This application requests that the Davis-Besse Nuclear Power Station Unit 1 Technical Specification, Appendix A, be revised to reflect the changes attached. The proposed changes include 1) addition of requirements on the interim anticipatory reactor trip system in sections 3.3.2.3, 4.3.2.3 and Table 3.3-15 and Table 4.3-15; 2) addition of requirements for auxiliary feedwater flow indications in section 4.7.1.2; 3) change to reactor coolant high pressure reactor trip setpoint in Table 2.2-1; 4) addition of a reactor coolant pressure temperature curve, Figure 3.4-5; 5) addition of requirements in sections 3.4.3 and 4.4.3 for the electromatic relief valve; 6) change to technical specification basis 2.2.1; and 7) change to SFAS actuation mode and actions of Tables 3.3-3 and 4.3-2.

APPLICATION FOR AMENDMENT
TO
FACILITY OPERATING LICENSE NO. NPF-3
FOR
DAVIS-BESSE NUCLEAR POWER STATION
UNIT NO. 1

Docket No. 50-346
License No. NPF-3
Serial No. 527
July 13, 1979

Figure 3.4-5 Reactor Coolant System Emergency Pressure/Temperature Limit Curve. Applicable for two effective full power years after June, 1979.

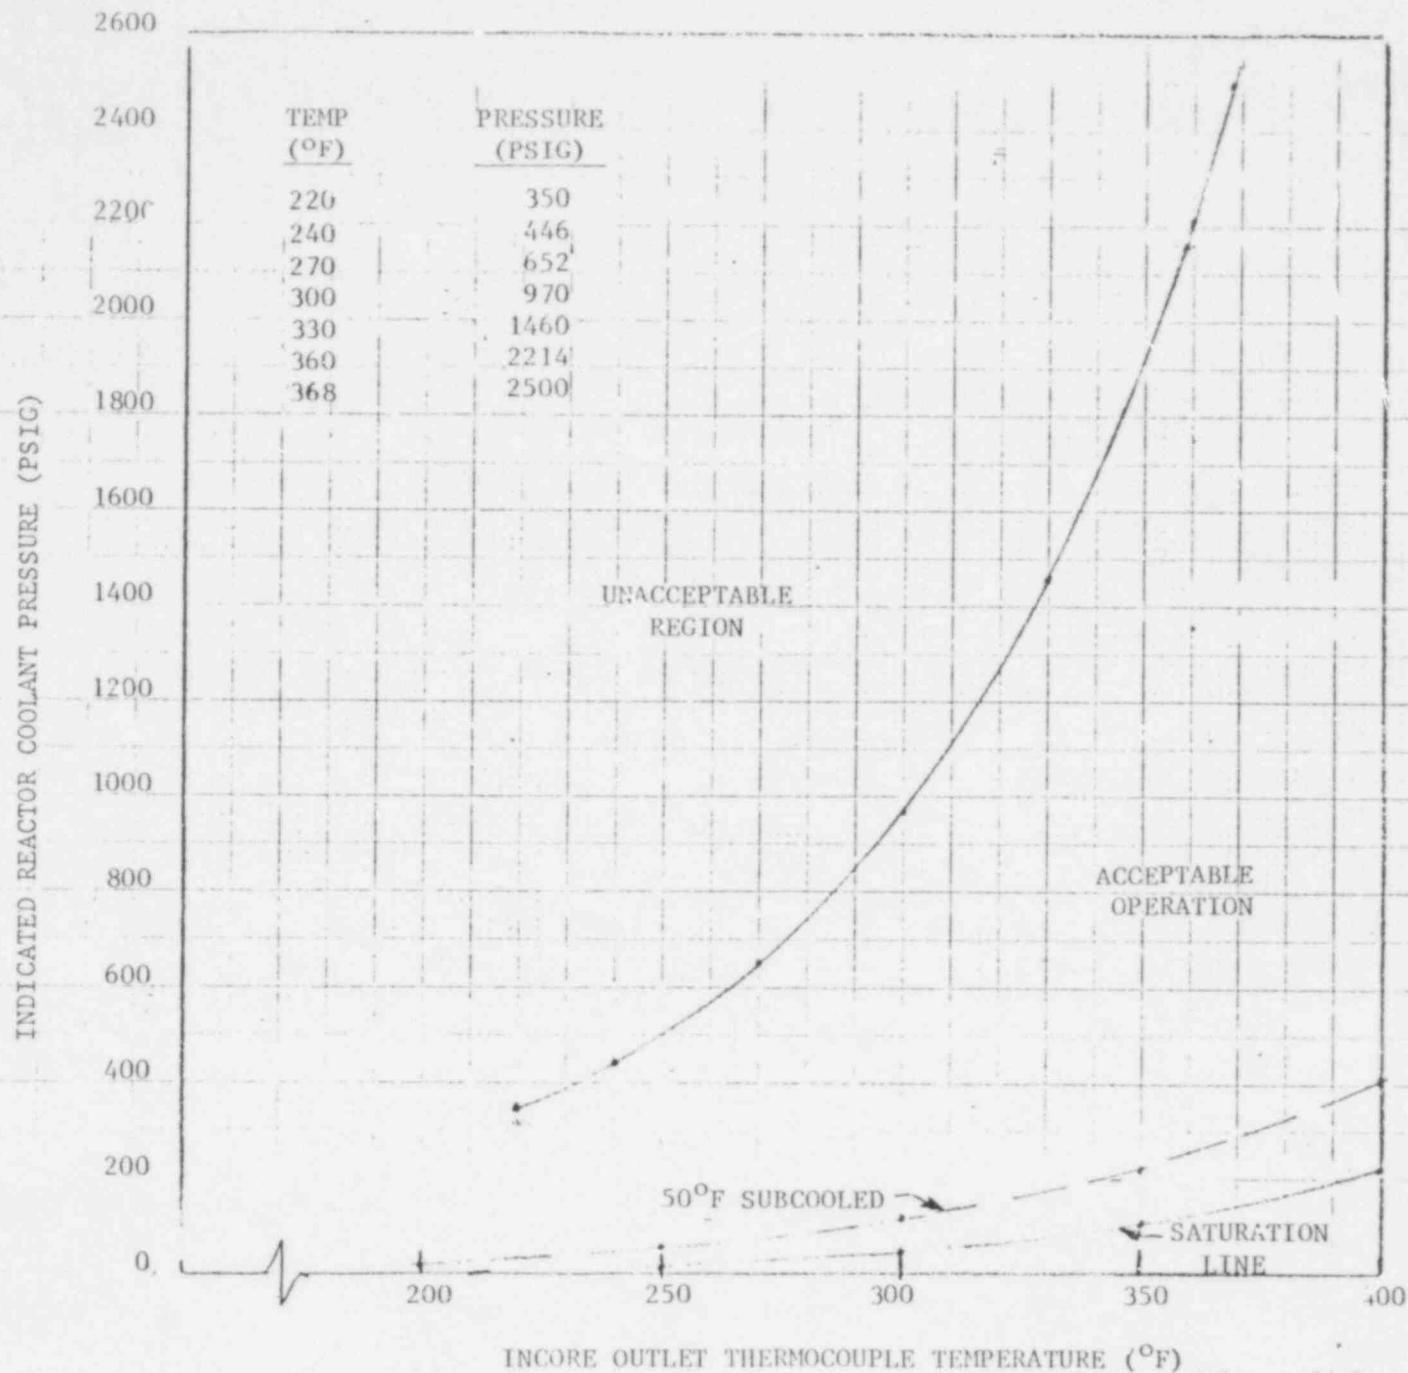
- IV Change to Davis-Besse Nuclear Power Station, Unit 1 Technical Specifications, Appendix A - Section 3.4.9.3, Figure 3.4-5 and Bases section 3/4 4.9 - concerning reactor coolant pressure and temperature limitations during emergency conditions - see attached proposed changes.

The pressure-temperature line for saturated water has been plotted in Figure 3.4-5 to indicate that this line is well below the acceptable limit curve for avoidance of reactor vessel brittle fracture concerns during small LOCA events. Because the saturation line is well away from the brittle fracture limit, it is evident that significantly subcooled pressure and temperature conditions, i.e., >30F, must be reached at the core outlet before the brittle fracture limits are approached. Having established these conditions, the operator may throttle high pressure injection to maintain the reactor coolant system pressure below the allowable pressure-temperature curve and still be confident that adequate core cooling is being maintained.

3.4.9.3 In the emergency/faulted condition that there is no forced or natural circulation in the reactor coolant system and there is high pressure injection and/or makeup addition, the Reactor Coolant System temperature and pressure shall be limited in accordance with the limit line shown on Figure 3.4-5. Under the above emergency/faulted conditions, Figure 3.4-3 will not apply.

Figure 3.4-5 takes into consideration that the reactor coolant system loop temperature sensors in the hot and cold legs cannot be relied upon as accurate indications of temperature conditions at the reactor vessel wall. The pressure/temperature limitations for this transient are given in Figure 3.4-5. The temperature scale in the curve has been shifted upward by 150°F to conservatively account for the temperature difference between the expected mixed average temperature in the reactor vessel downcomer and the temperature at the core exit. The pressure/temperature limits in Figure 3.4-5 were derived by removing the factor of two conservatism from allowable pressure which is prescribed in Appendix G. In other respects, the curve has been calculated to meet the prescription of Appendix G.
